REPORT FROM INFRASTRUCTURE UNIT FOR THE MONTH OF AUGUST

PROPOSED WOMBAT CROSSINGS UNDOOLYA ROAD AND STURT TERRACE, ALICE SPRINGS

Figure 1: Concept roundabout design (Source: Greenhill Engineers)

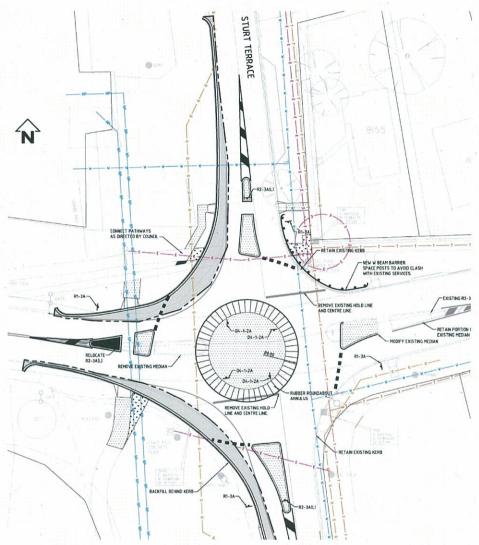
The operation of both a roundabout and a wombat crossing are governed by the Australian Road Rules. Essentially, drivers on approach to the roundabout must give-way to all other drivers on the roundabout and drivers much give-way to pedestrians on the crossings.

I am also in receipt of correspondence from the Alice Springs Cycling Club which has raised concern in respect to the provision for on-road cyclists at the roundabout. The correspondence, amongst other comments, provides the following suggestion:

"It is critical that the road is wide enough right around the roundabout to enable cyclists and cars to enter fluidly and travel together if necessary. A one metre cycling lane would be ideal."

Recent research has indicated that a dedicated bicycle lane through the roundabout is actually a less safe treatment than ensuring a cyclist can claim their space. Nonetheless, we agree with the cyclist club that the design should provide appropriately for cyclists.

In order to determine the safest and most appropriate traffic control solution, relevant traffic control data should be collected to ascertain the movements which need to be catered for. This would include collection of the following data:

Based on these data, design solutions can be developed for the intersection, which considers all road users, including integration of a safe solution for pedestrians and cyclists.

Figure 2: Potential queuing issue with wombat crossings adjacent roundabout

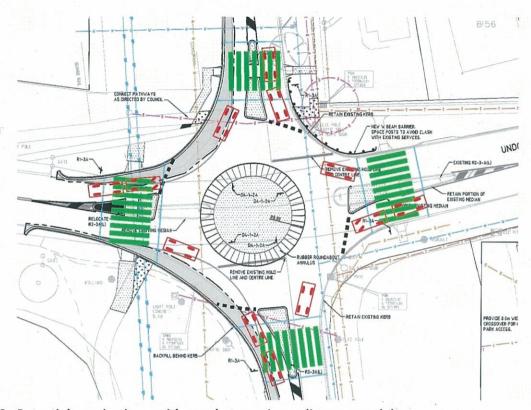
The issue with a priority pedestrian crossing facility being close to an intersection (be it treated with a roundabout or otherwise) is one of queuing. A queue of vehicles at a roundabout crossing would likely extend into the intersection (roundabout). This will make the roundabout inoperable but more importantly, result in potential safety issues for vehicle's occupants. Similarly, vehicles queued at the roundabout could extend across the wombat crossing. While drivers are required to not queue across a crossing, this is often difficult to judge and would result in the crossing being obstructed for pedestrians and the resultant pedestrian/vehicle conflict. Figure 2 illustrates the potential queuing and conflict issues at a roundabout with adjacent wombat crossings.

It can be seen on the above figure that there would be inadequate distance for drivers to queue without obstructing the crossing or the roundabout. While the crossings could be set further back, this would remove them from the pedestrian desire lines, resulting in a potential for non-compliance of the device.
